In the Drawings

The attached replacement and annotated sheet(s) of drawings include changes to FIG. 1 and FIG. 2 as follows:

ROBERT E. KREBS, THELEN REID & PRIEST LLP
 Serial No.: 09/885,811
 Filed: June 19, 2001
 TRP DOCKET NO.: 034942-245
 Annotated Sheet Showing Changes

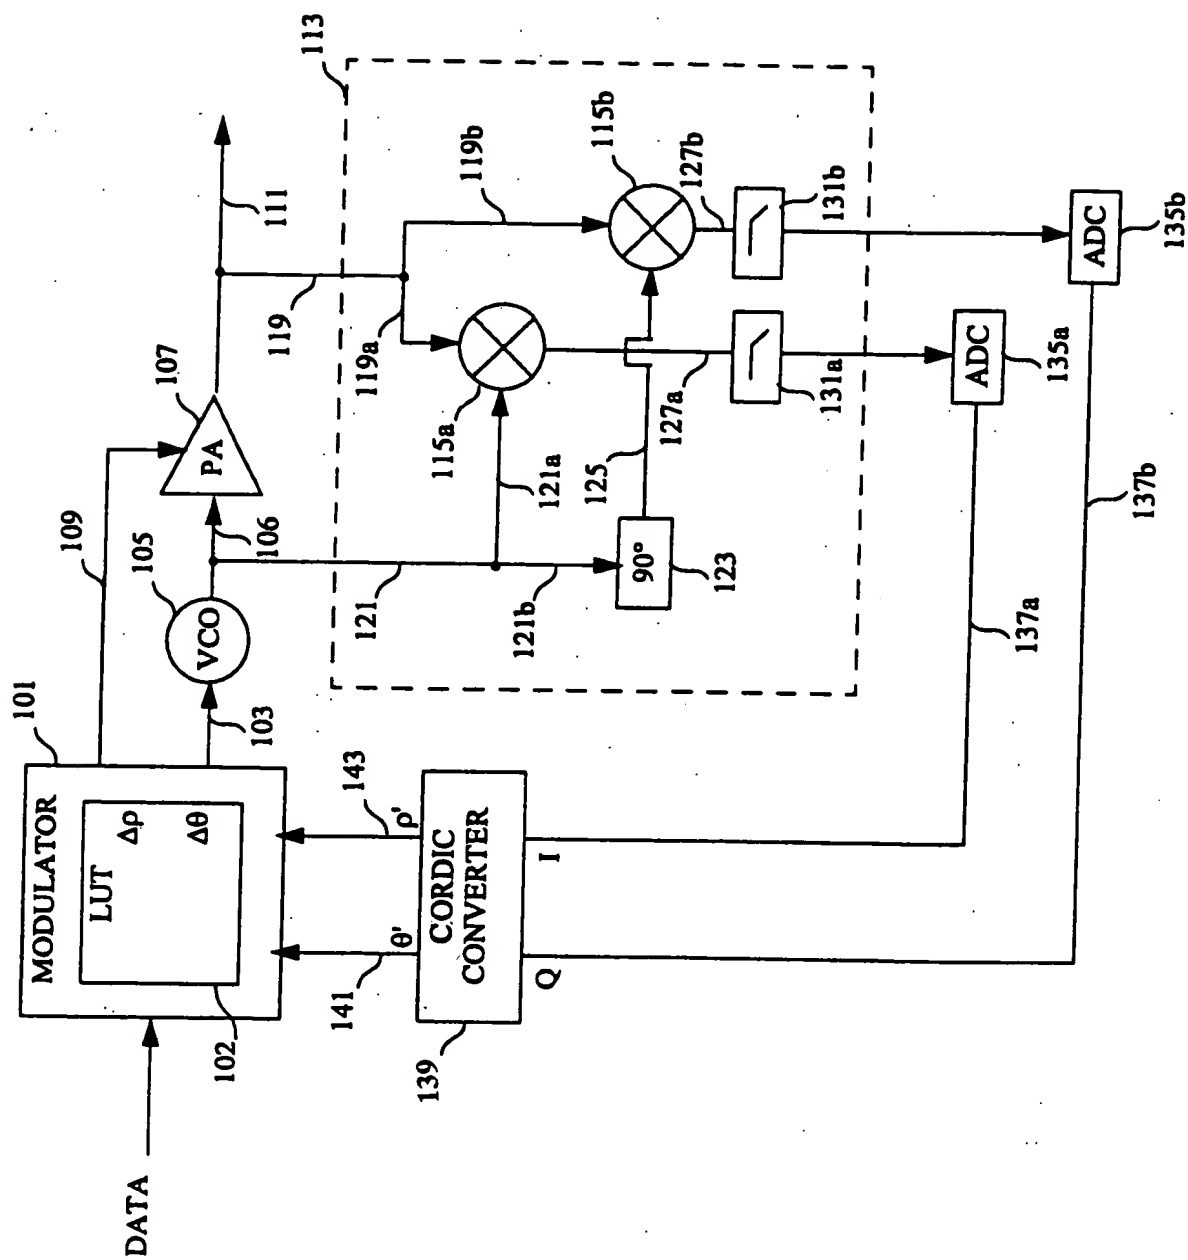
FIG. 1 has been amended such that box 121 has been relabeled 139 for consistency with the specification, and the descriptive legend has been changed from “chordic converter” to “cordic converter” to thereby correct the misspelling.

Fig. 2

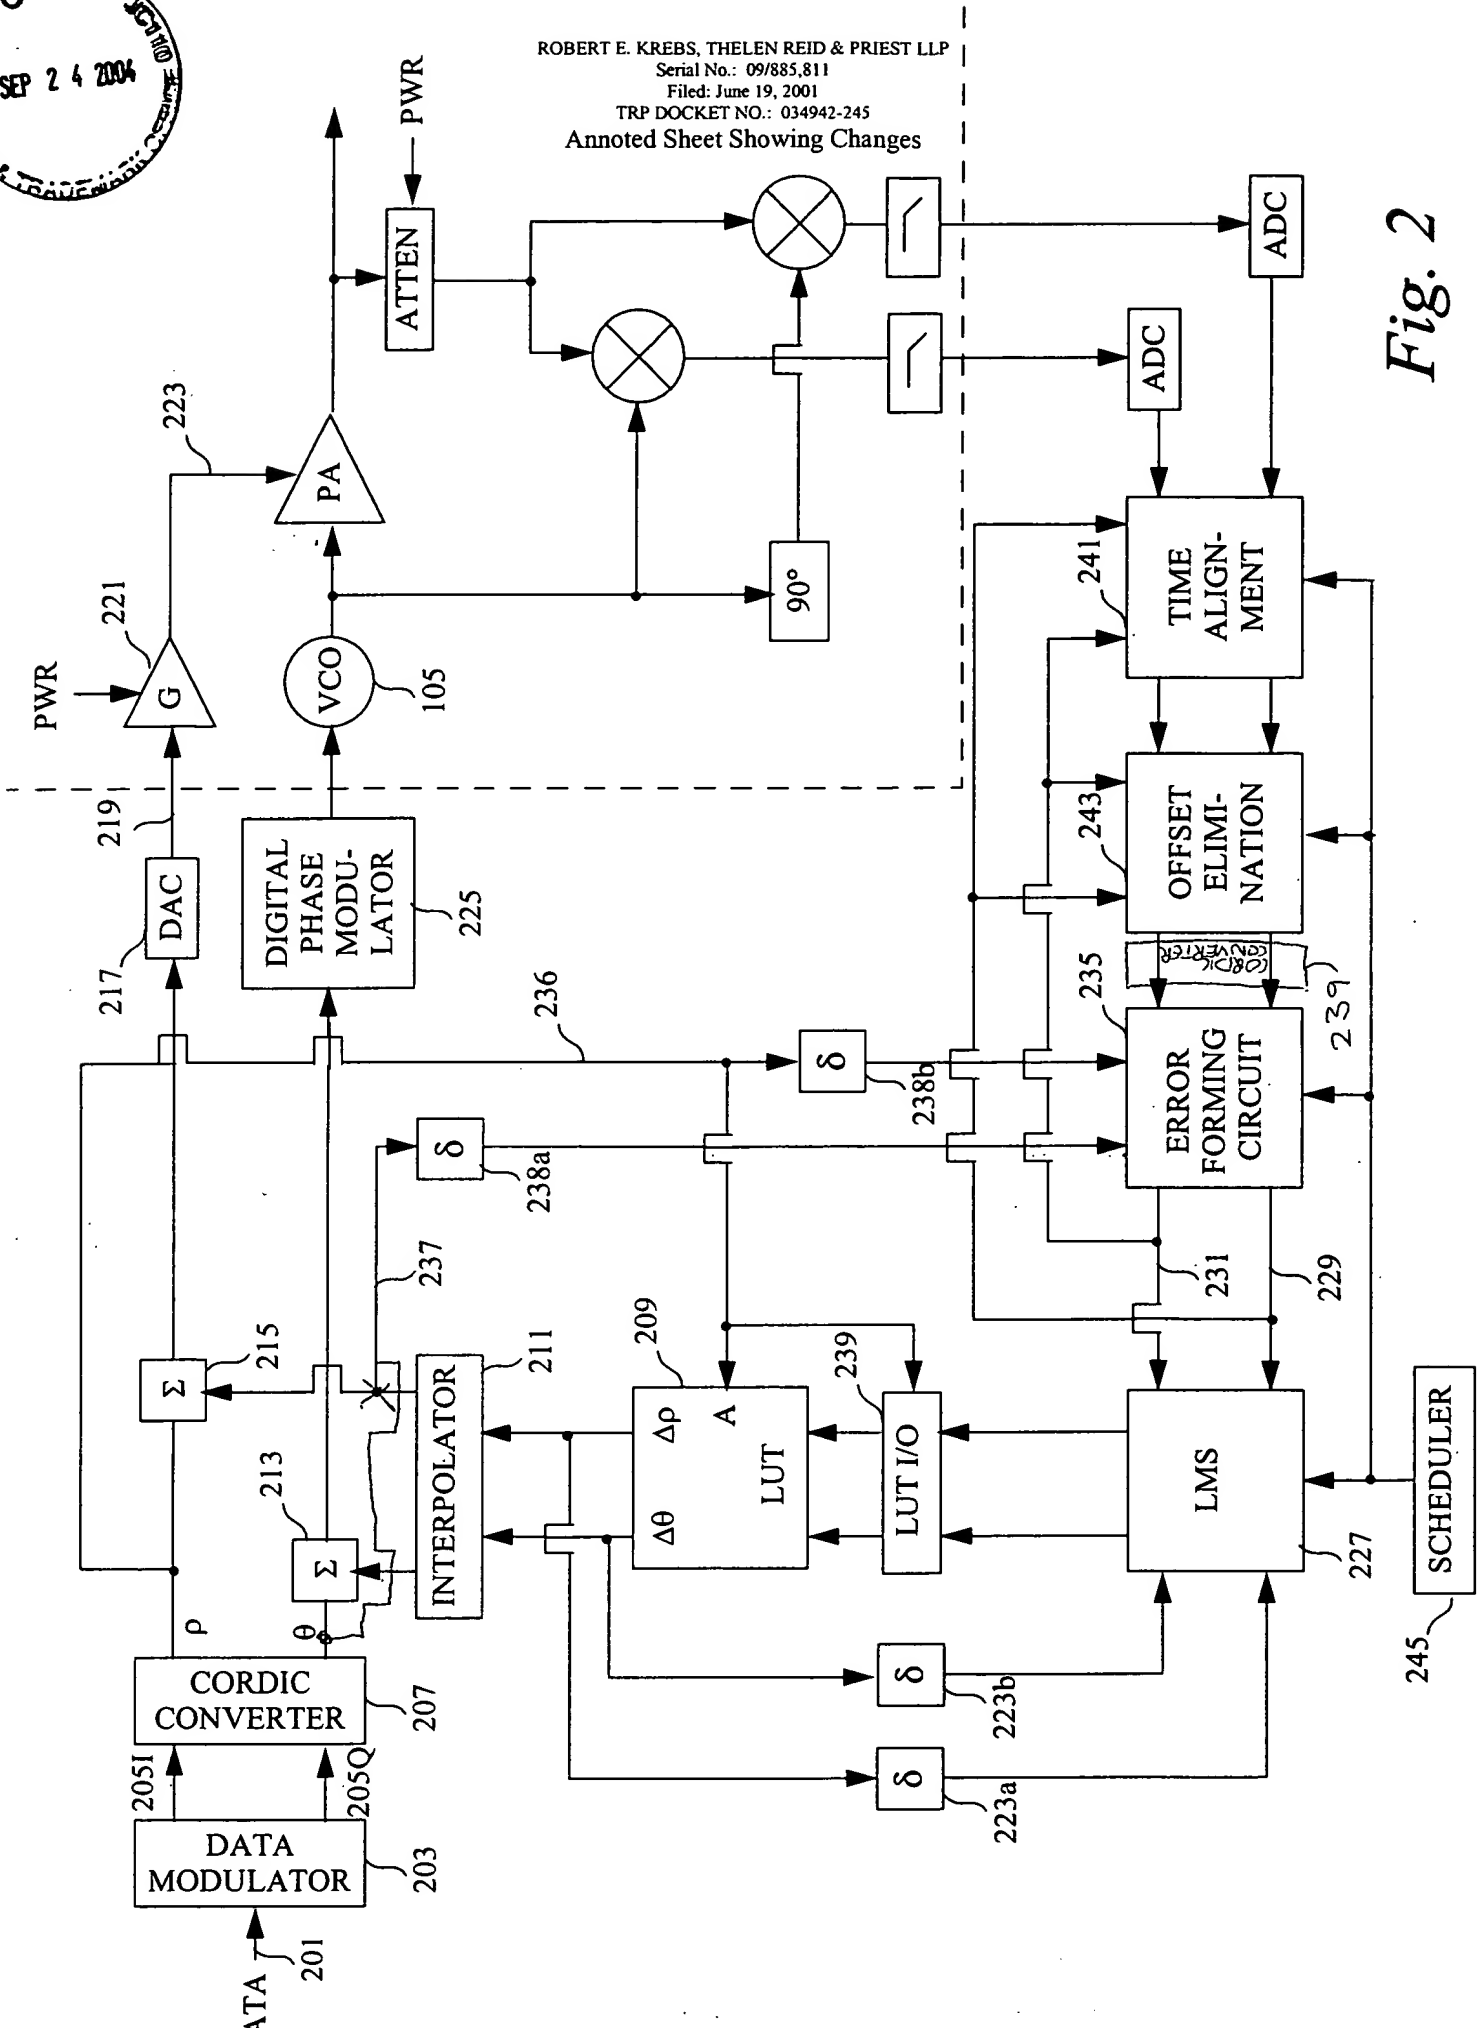
FIG. 2 has been amended to re-route the connection 237 to the delay element 238, and to insert cordic converter 139 of FIG. 1 in its proper place for consistency with FIG. 1 and the remainder of the description.
